CRADLE & VIAL

Tooling Modifications

Analysis and Recommendations

September 22, 2003

Illustration 2

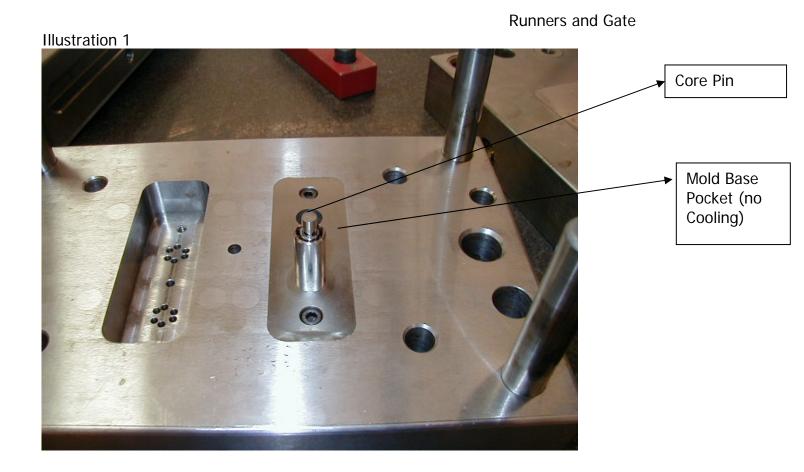
Bob Allen, project engineer at Inland Technologies reiterated his concerns regarding molding difficulties in terms of using maximum pressure and mold temperature to mold these parts. Mold was taken apart and each component was analyzed. In order to improve mold filling by reducing injection pressure, we decided to enlarge the gate by 50 percent, improve venting and open up the runner system to reduce pressure drop through the gate. If the maximum plastic pressure available from the machine is 20,000 psi and if the plastic pressure required to fill the cavity is 6000 psi (not unusual for a thin walled part), the pressure loss from the machine nozzle, sprue, runner system and gate cannot exceed 14,000 psi. Therefore, reducing the pressure loss through the runner system and gate makes logical sense (illustration 1). It is guite possible that by reducing injection pressure required to fill the part, we may be able to lower the mold temperature. This should help the part mushrooming situation since the part will be sufficiently cooled to allow ejection at lower pressure. However, a more permanent solution is to find a way to provide better cooling in the core pin. Since it is not feasible to add water in the core pin, the suggestion is made to make the core pin out of highly thermally conductive material such as Ampcoloy®. These copper alloys have six to nine times greater heat transfer than convention mold steels. However, they do exhibit lower wear characteristics. Additional recommendation includes enlarging the mold base pocket (illustration 2) to accommodate a larger insert with waterlines to enhance heat transfer between Ampcoloy® core pin and insert. Also under consideration is application of Poly-Ond®

coating (Nickel phosphorus coating impregnated with Teflon) on core surface to improve release of the part.

Current	Proposed
Sprue Diameter	.250	.250
Primary Runner Diameter	.156	.200
Secondary Runner Diameter	.141	.175
Gate	.030	.045
Core pin Material	Steel	Ampcoloy
Core pin Plating	None	Poly-Ond

Illustration 3

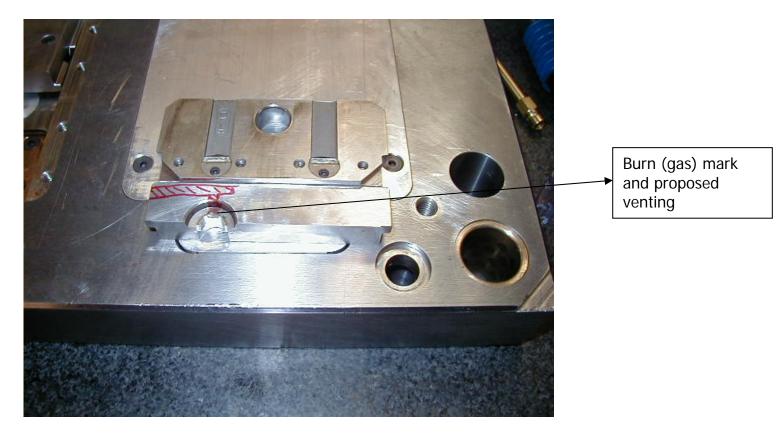
A close examination of the insert shows a slight burning (indicated by black mark) indicating gas trap or inadequate venting situation. Tooling will be modified to improve venting as shown in the illustration 3.
